SPRINGHILL PLACE SUBDIVISION

The purpose of the application is to create an eight-lot subdivision from a metes and bounds parcel.

APPLICATION NUMBER 14 DATE April 5, 2007

DETAIL SITE PLAN

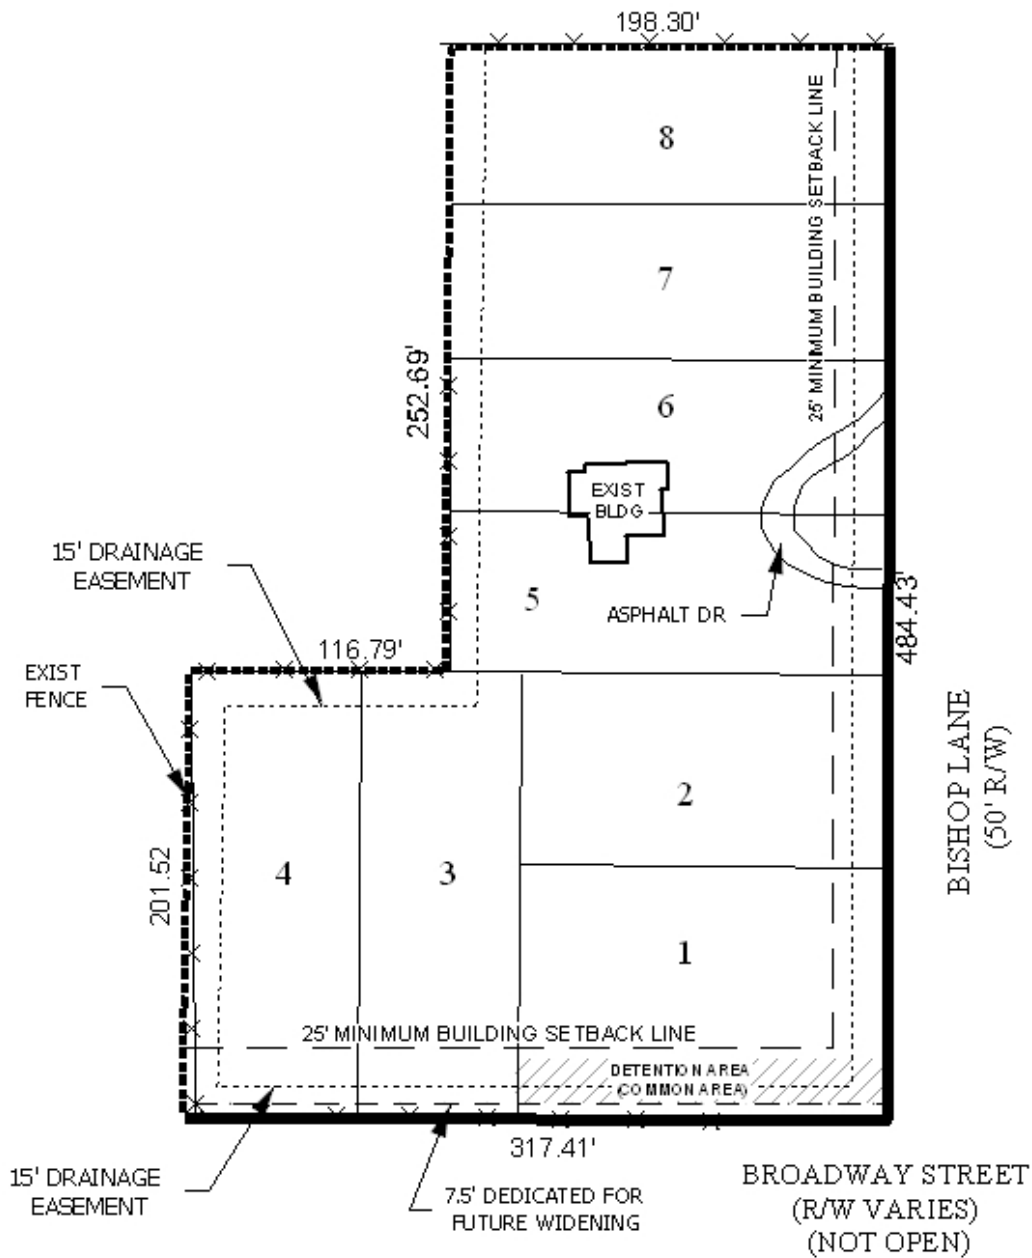
The site fronts Bishop Lane, which has a 50-foot right-of-way, and an unopened right-of-way for Broadway Street, which ranges from approximately 35 to 40 feet in width adjacent to the site. The plat illustrates dedication of 7.5 feet for future construction of Broadway Street. However, a radius is not provided at the intersection of Bishop Lane and Broadway Street..

The plat now before the Commission is virtually identical to the plat that was approved in 2005, with the exception of the 15-foot wide strip of common area, which is now shown as a drainage easement. The plat reflects several grate inlets which will conduct stormwater to the detention system provided in a common area at the Southeast corner of the site. Some modifications to this detention system may be required to accommodate the dedication of a radius at the intersection of Bishop Land and Broadway Street.

The plat contains a note indicating that the existing house and asphalt drive on the site are to be removed; this would need to be accomplished and verified prior to signing the final plat.

- 1) dedication along Broadway Street to provide 25' from centerline, as shown on the plat submitted;
- 2) dedication of an appropriate radius at the intersection of Broadway Street and Bishop Lane, to be approved by City Engineering and Traffic Engineering;

- 3) modification of stormwater detention facilities to accommodate the dedication for radius, if necessary, to be approved by City Engineering;
- 4) preservation of the 70" Live Oak Tree on the West side of Lot 6, with any work on or under this tree to be permitted and coordinated with Urban Forestry, and removal to be permitted only in the case of disease or impending danger;

- 5) removal of the existing house and drive prior to signing the final plat;
- 6) the placement of a note on the final plat stating that maintenance of common areas will be the responsibility of the property owners;

- 7) the placement of a note on the final plat stating that each lot is limited to a single curb cut; and
- 8) the depiction of the 25-foot setback for all lots (measured from the Broadway Street dedication, for lots 3 and 4).
